Office Office	State of New Mex	ico	Form C-103		
<u>District I</u> – (575) 393-6161	Energy, Minerals and Natura	al Resources	Revised July 18, 2013		
1625 N. French Dr., Hobbs, NM 88240 District II – (575) 748-1283			L API NO.		
811 S. First St., Artesia, NM 88210	OIL CONSERVATION I	5 In	30-025-47137 5. Indicate Type of Lease		
<u>District III</u> – (505) 334-6178 1000 Rio Brazos Rd., Aztec, NM 87410	1220 South St. Franc	as Dr.	STATE X FEE		
<u>District IV</u> – (505) 476-3460	Santa Fe, NM 875	6. St	ate Oil & Gas Lease No.		
1220 S. St. Francis Dr., Santa Fe, NM 87505					
	CES AND REPORTS ON WELLS	7. Le	ase Name or Unit Agreement Name		
	SALS TO DRILL OR TO DEEPEN OR PLUC CATION FOR PERMIT" (FORM C-101) FOR		- 4 D T T L D O D 4 7 O T 4 T F		
PROPOSALS.)	1 "	HEARTTHROB 17 STATE 8. Well Number 2014

Heartthrob 17 State #201H Lea County, New Mexico

Revised Wellbore 1/21/2021

Revised Permit Information 1/21/2021:

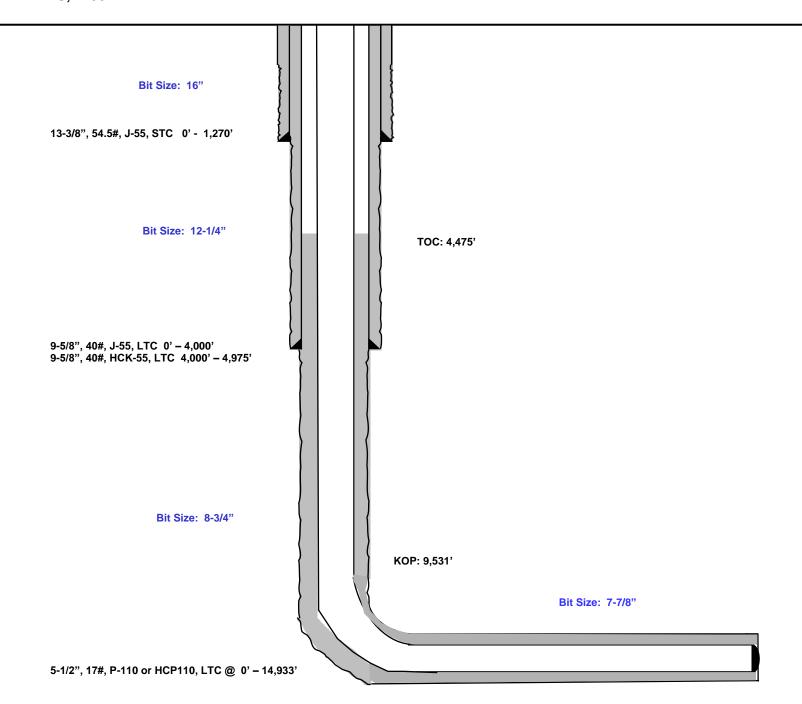
CLOSED-LOOP SYSTEM OTHER: 13. Describe proposed or compof starting any proposed we proposed completion or recent EOG respectfully required Change surface hole	leted operations. (Clearly state all peork). SEE RULE 19.15.7.14 NMAC. completion. uests and amendment to our ap size to 16"	rtinent details, and give proved APD for this w	pertinent dates, including estimated date ns: Attach wellbore diagram of		
CLOSED-LOOP SYSTEM OTHER: 13. Describe proposed or compof starting any proposed we proposed completion or recent EOG respectfully required Change surface hole	leted operations. (Clearly state all peork). SEE RULE 19.15.7.14 NMAC. completion. uests and amendment to our ap size to 16"	rtinent details, and give proved APD for this w	pertinent dates, including estimated date ns: Attach wellbore diagram of		
CLOSED-LOOP SYSTEM OTHER: 13. Describe proposed or compof starting any proposed we proposed completion or recent EOG respectfully required Change surface hole	leted operations. (Clearly state all peork). SEE RULE 19.15.7.14 NMAC. completion. uests and amendment to our ap size to 16"	rtinent details, and give proved APD for this w	pertinent dates, including estimated date ns: Attach wellbore diagram of

EOG respectfully requests to retain the option to drill 8-1/2" production hole in the curve and lateral.

Hole Size	Interval	Csg OD	Weight	Grade	Conn	DF _{min} Collapse	DF _{min} Burst	DF _{min} Tension
16"	0'-1,270'	13.375"	54.5#	J-55	STC	1.125	1.25	1.60
12.25"	0'-4,000'	9.625"	40#	J-55	LTC	1.125	1.25	1.60
12.25"	4000' – 4,975'	9.625"	40#	HCK-55	LTC	1.125	1.25	1.60
8.75"	0'-9,531'	5.5"	17#	HCP-110	LTC	1.125	1.25	1.60
7.875"	9,531'-	5.5"	17#	HCP-110	LTC	1.125	1.25	1.60
	14,933'
